Access Compliance Report

Public Rights-of-Way

(Curb Ramps)

Intersection ID: 20129	Main Street: NATIONS_DR	Cross Street: NATIONS_FORD_RD	Location: SW
ADA ID: D338F31F6D24	Ramp Type: PerpDiag	Initial Pass/Fail: Fail	Overall Compliance: No
Severity Score: 21.25			
Codes/Mitigation Info/Possible Solution		Field Measurements/Component Compliance

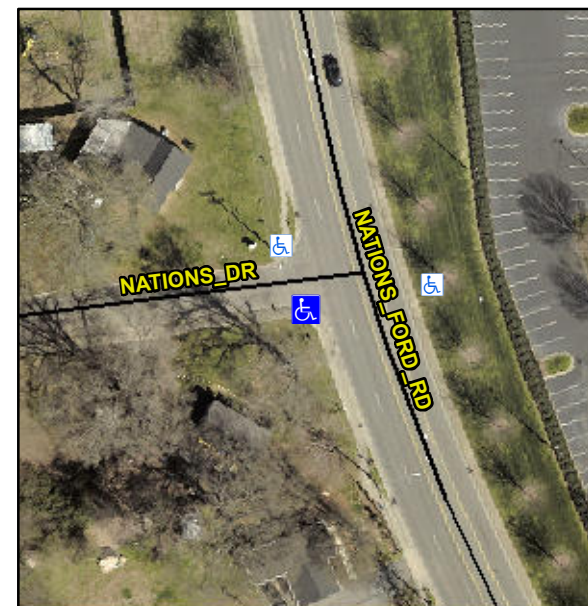
R304.5.1, R304.2.2

Compliance	Description	Data	Compliance	Description	Data
N/A	Ramp Length (in)	55.0	No	Ramp Slope (%)	8.7
No	Ramp Width (in)	37.0	Yes	Ramp XSlope (%)	1.6
N/A	Flare Type LT	N/A	N/A	Flare Type RT	N/A
N/A	Flare Slope LT (%)	N/A	N/A	Flare Slope RT (%)	N/A
N/A	Flare Traversable LT?	N/A	N/A	Flare Traversable RT?	N/A
N/A	Landing Length (in)	N/A	N/A	DWS Provided?	N/A
N/A	Landing Width (in)	N/A	N/A	DWS Contrast?	N/A
N/A	Landing Slope (%)	N/A	N/A	DWS Length (in)	N/A
N/A	Landing X Slope (%)	N/A	N/A	DWS Full Width?	N/A
N/A	Landing Curb? (Y/N)	N/A	N/A	DWS Offset (in)	N/A
N/A	Shared Landing?	N/A			
N/A	Gutter Ponding?	N/A	N/A	Gutter Slope (%)	N/A
N/A	Gutter Lip Ht (in)	N/A	N/A	Gutter X Slope (%)	N/A
N/A	Painted X Walk1?	No	N/A	Painted X Walk2?	No
	X Walk 1 Direction	To E		X Walk 2 Direction	To N
N/A	X Walk 1 Width (in)	N/A	N/A	X Walk 2 Width (in)	N/A
	X Walk 1 Slope (%)	0.7		X Walk 2 Slope (%)	1.3
	X Walk 1 X Slope (%)	0.4		X Walk 2 X Slope (%)	1.8

Remove & Replace Curb Ramp With Two New Directional Ramps or Equivalent.
